ADDENDUM 1 – JOB 39

TO: All prospective bidders on project SOIB-CPU-7-023(050)910, Job No. 39 scheduled for the November 17, 2017 bid opening.

**ADDENDUM 1
JOB NO. 39**

TO: All prospective bidders and suppliers on Project SOIB-CPU-7-023(050)910, Job No. 39 in McKenzie County, scheduled for the November 17, 2017 bid opening.

STATE	PROJECT NO.	SECTION NO.	SHEET NO.
ND	SS-7-023(050)910	76	3

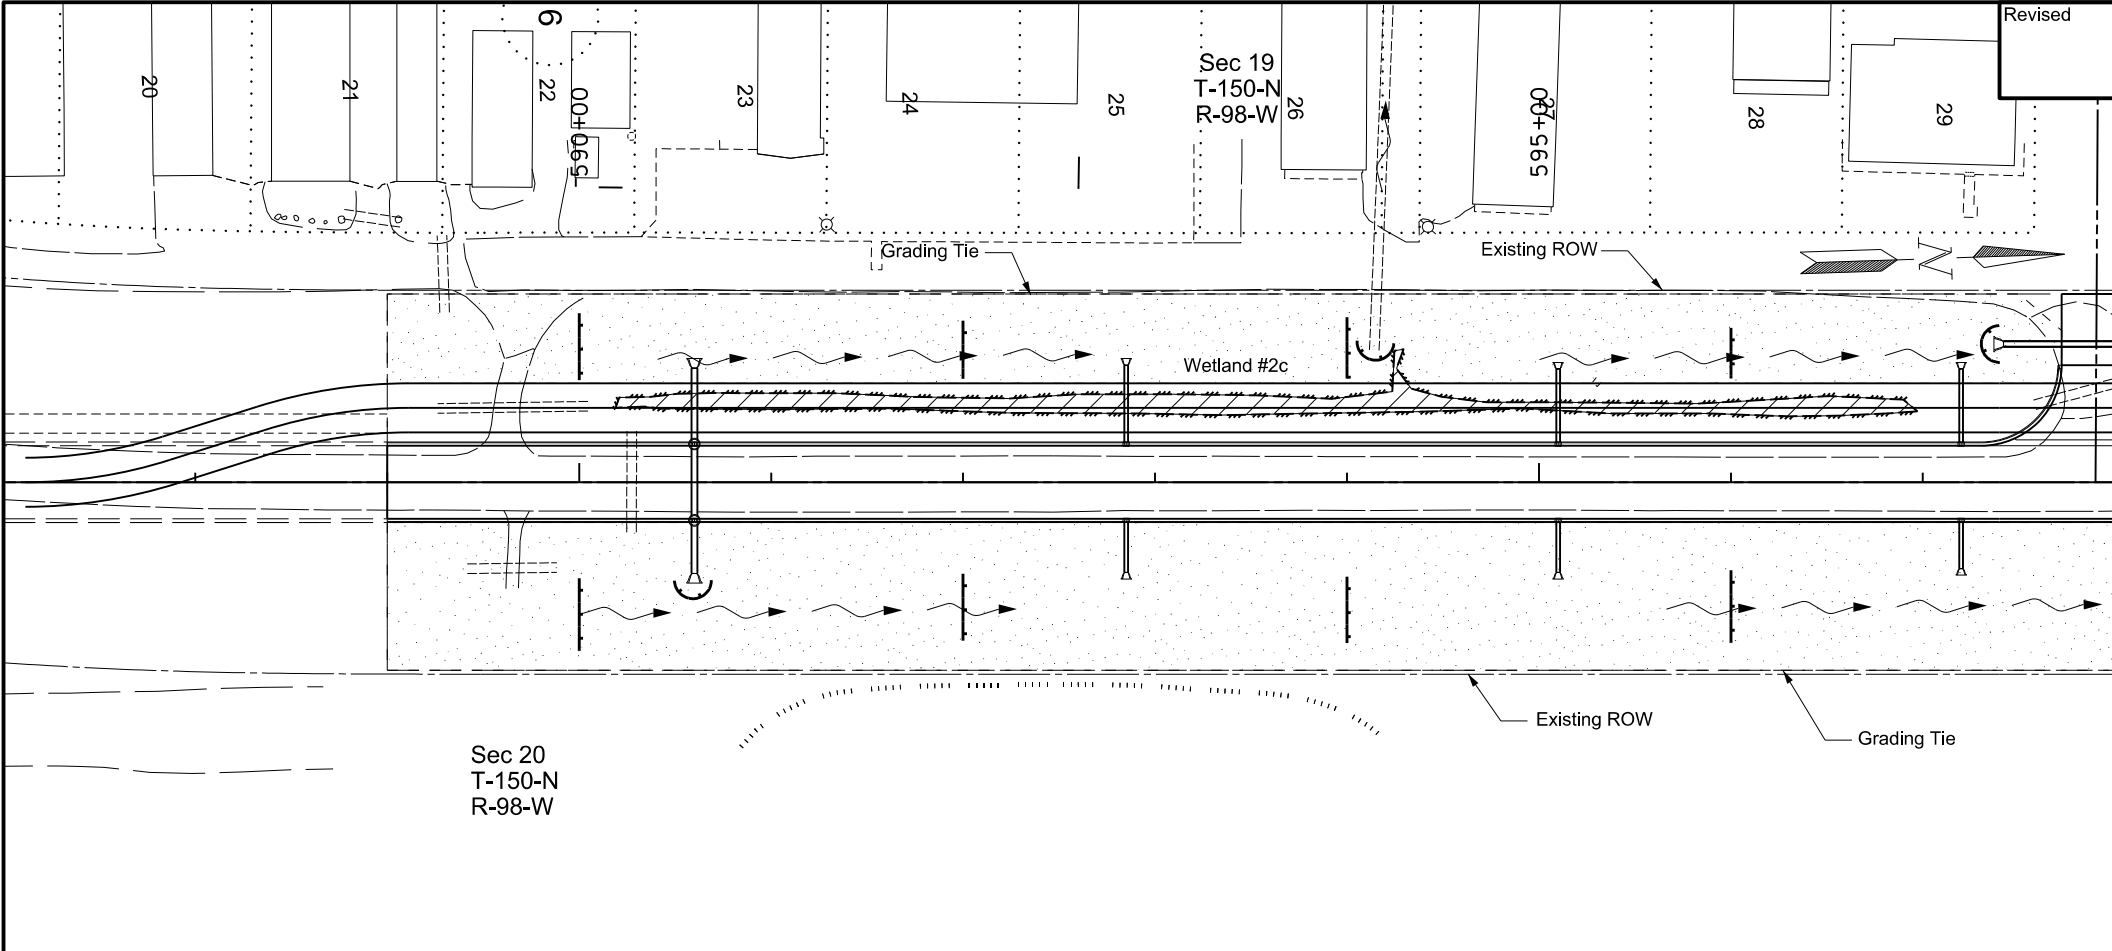
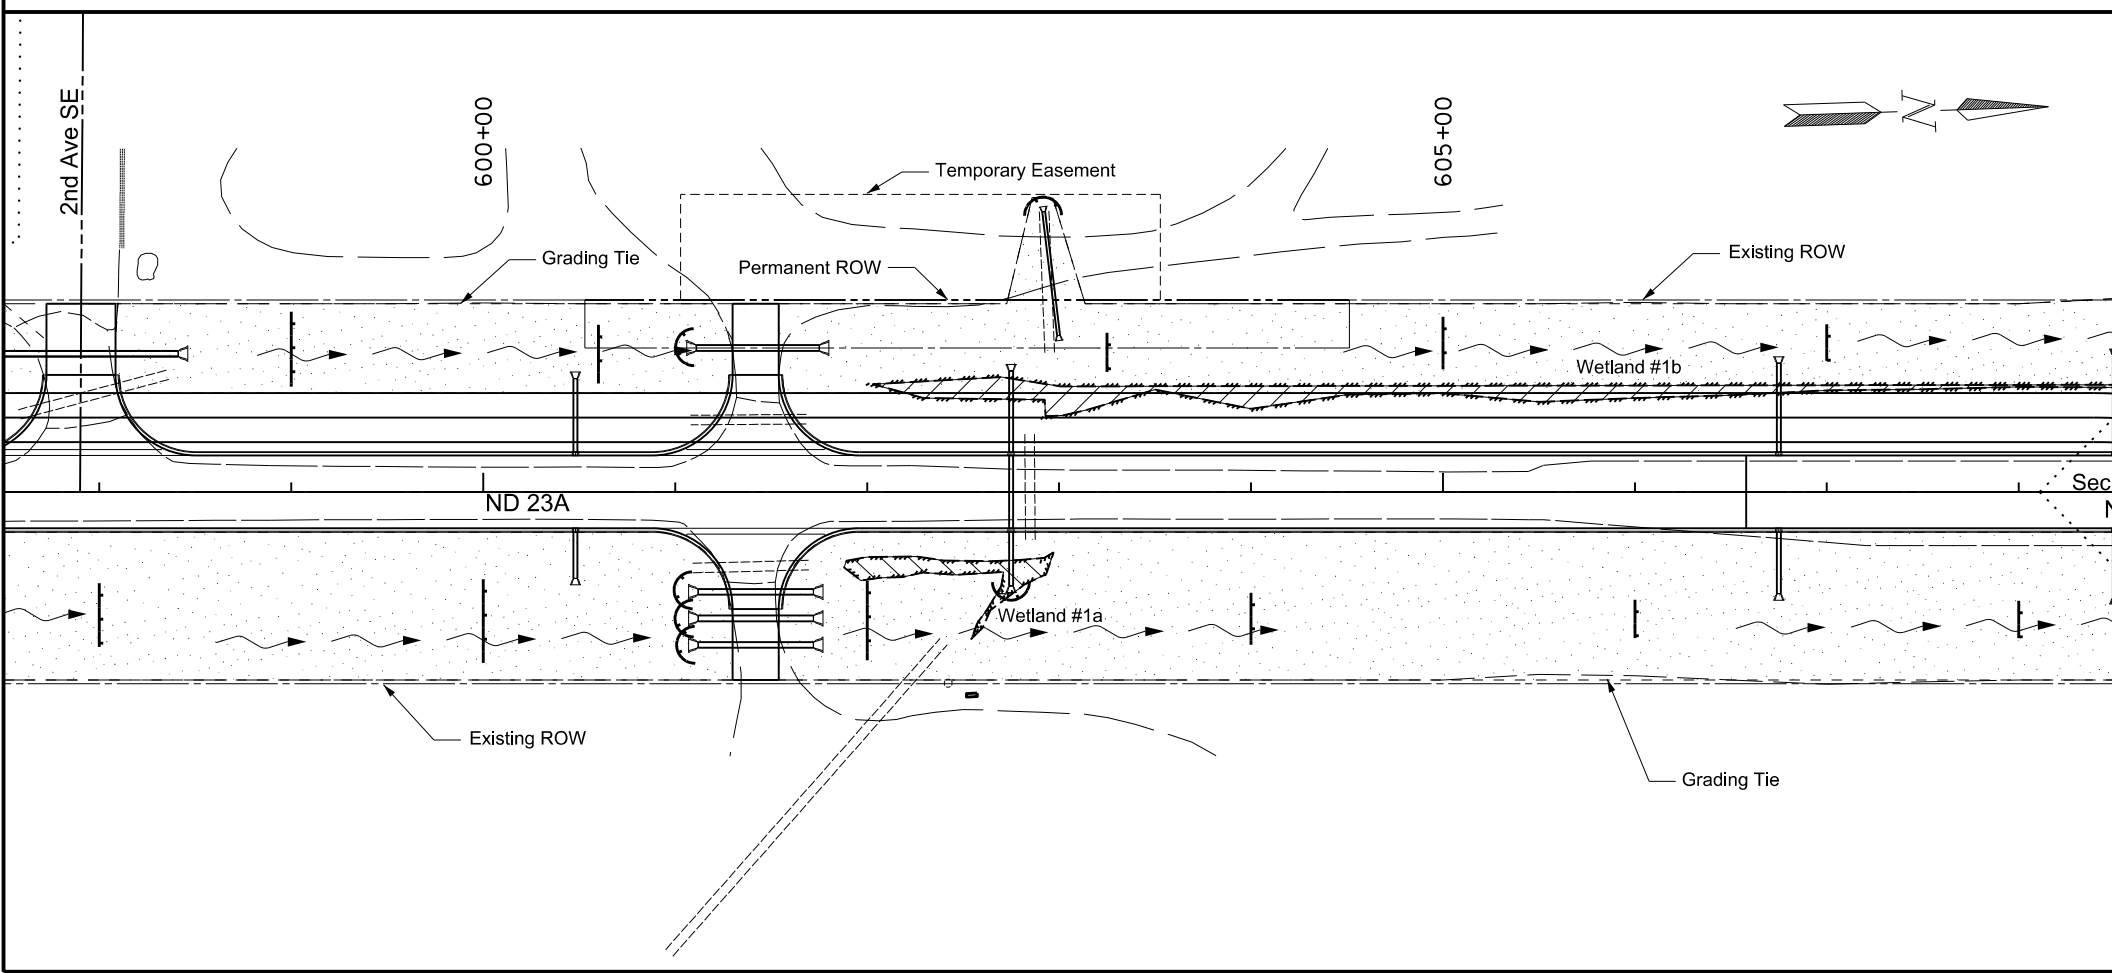
- Section 76, Sheet 2: The grading limits for the temporary bypass were updated.
- Section 76, Sheet 3: An additional fiber roll was added to the approach pipe at Station 601+42 Rt.

STATE	PROJECT NO.	SECTION NO.	SHEET NO.
ND	SS-7-023(050)910	77	3

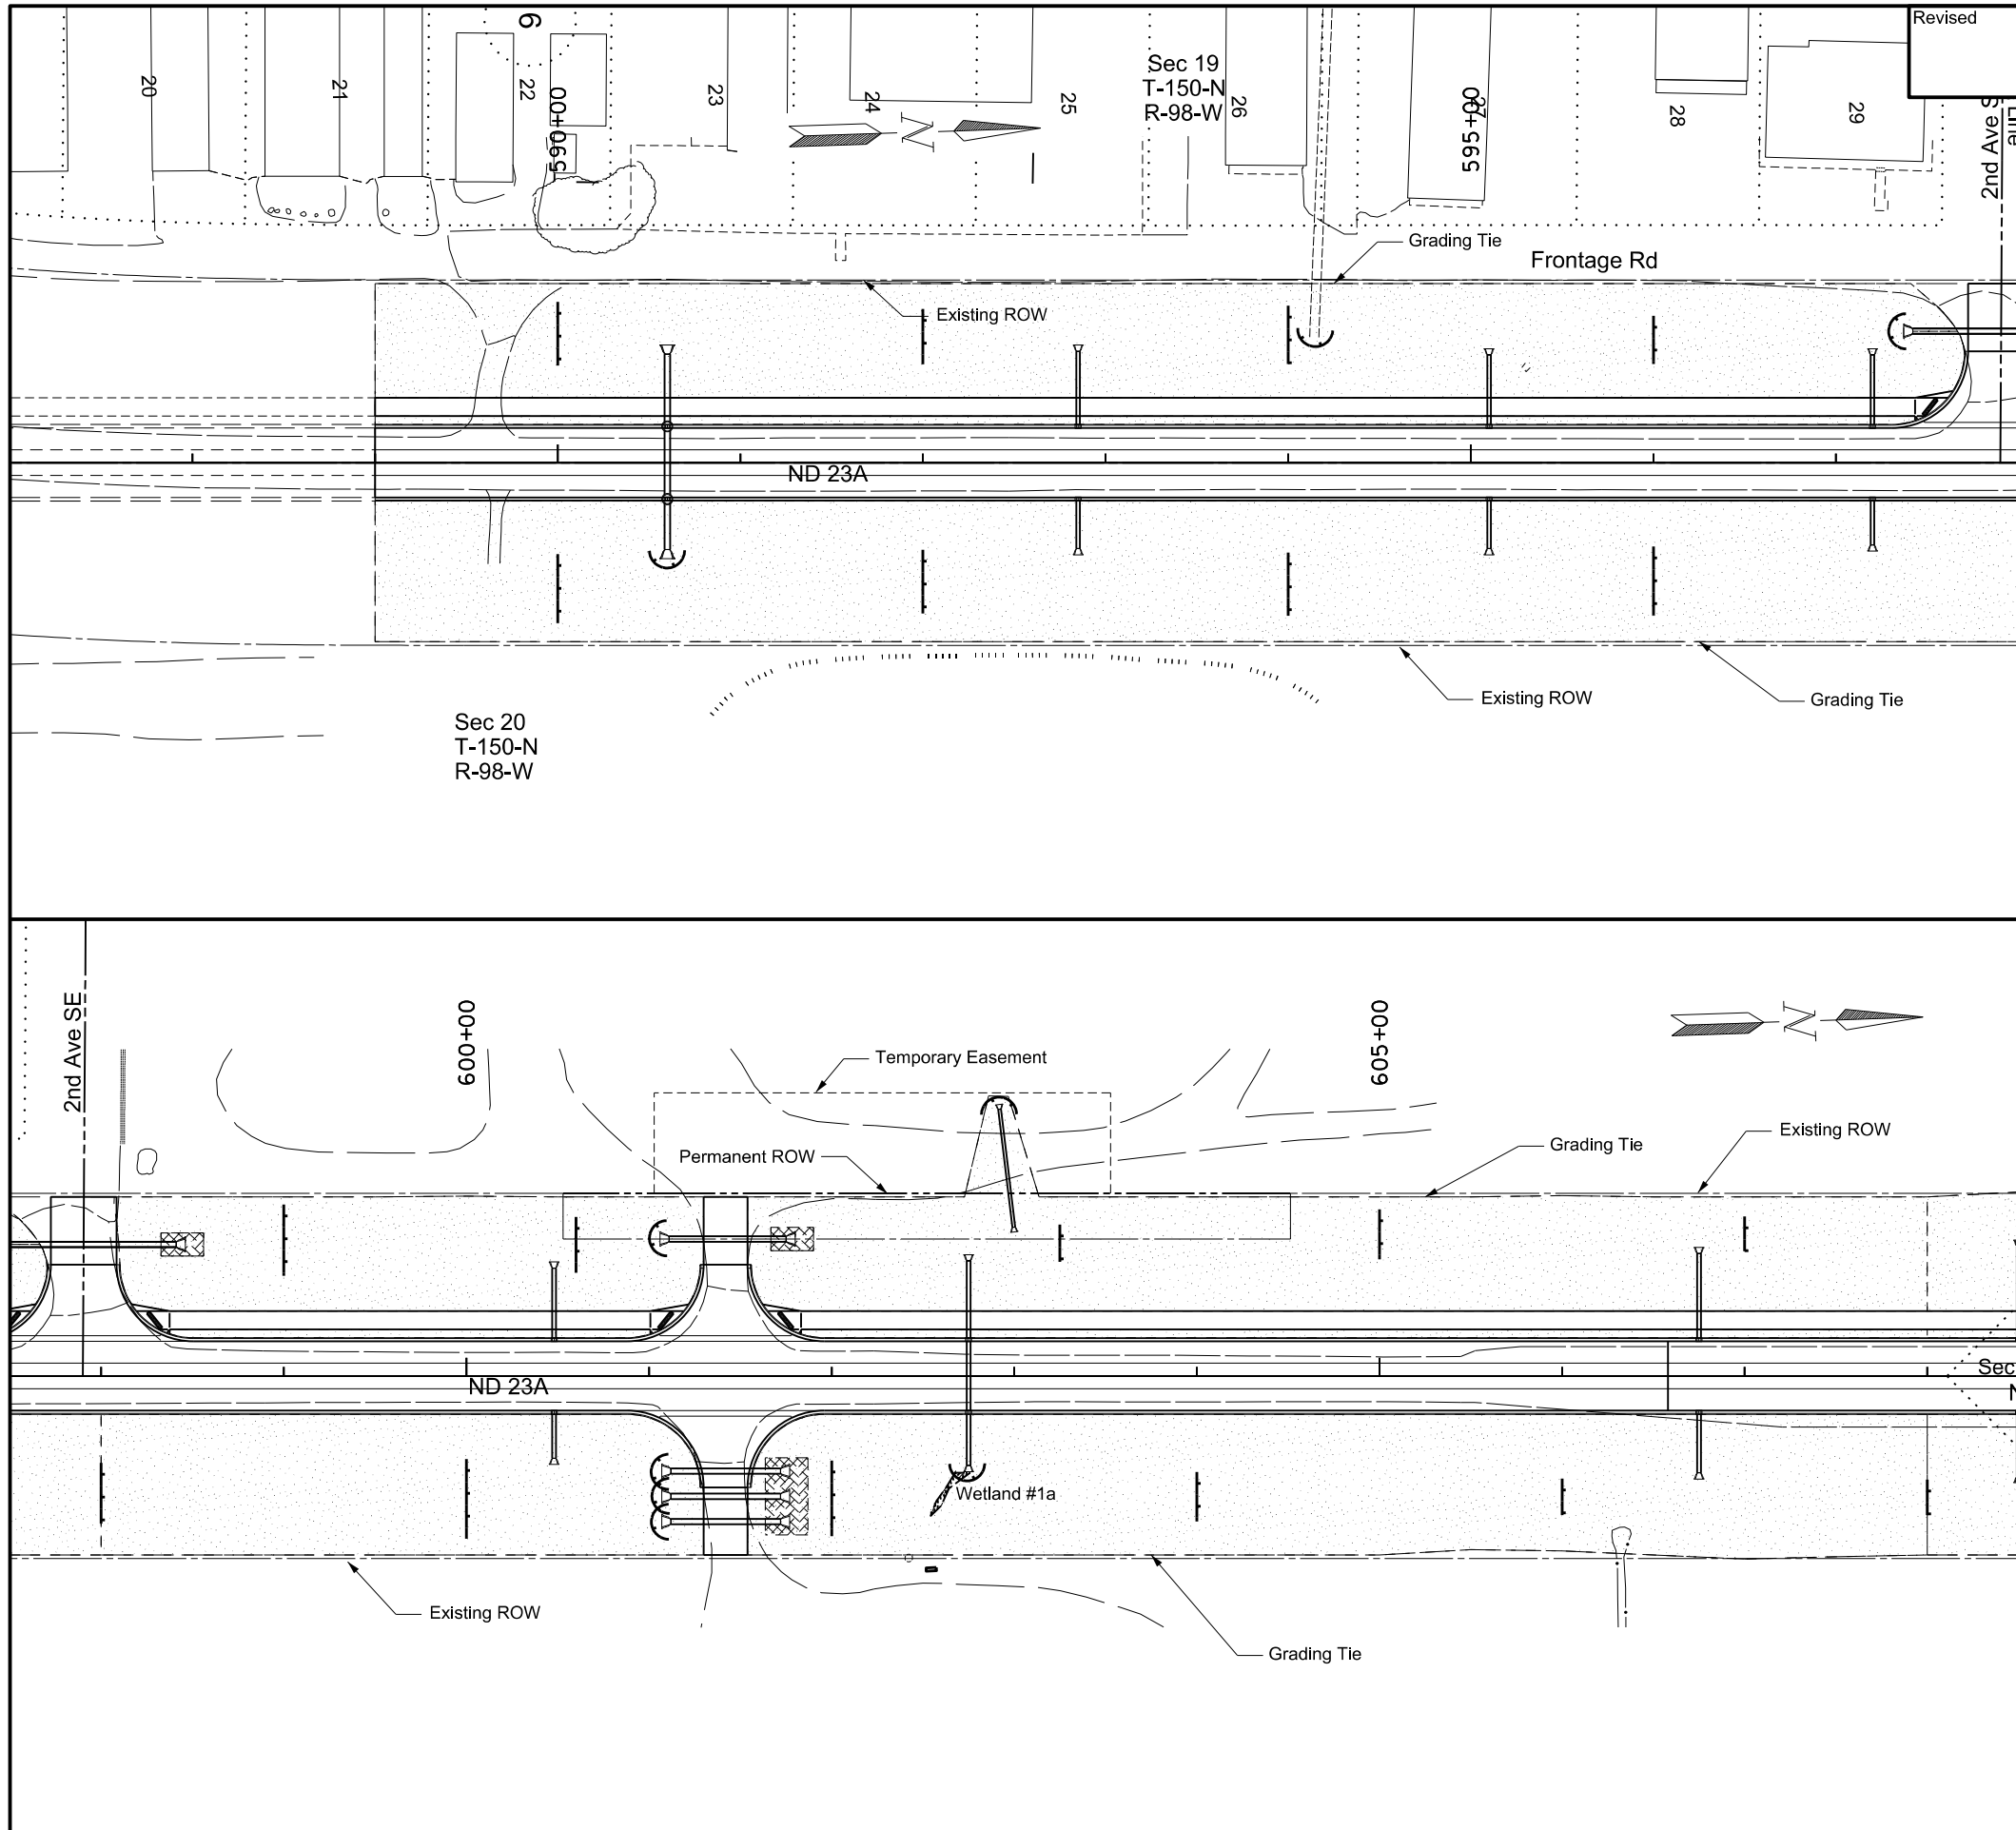
- Section 77, Sheet 3: An additional fiber roll was added to the approach pipe at Station 601+42 Rt.
- Section 77, Sheet 5: The Fiber Roll 12IN quantity and the Remove Fiber Roll 12IN quantity were updated.
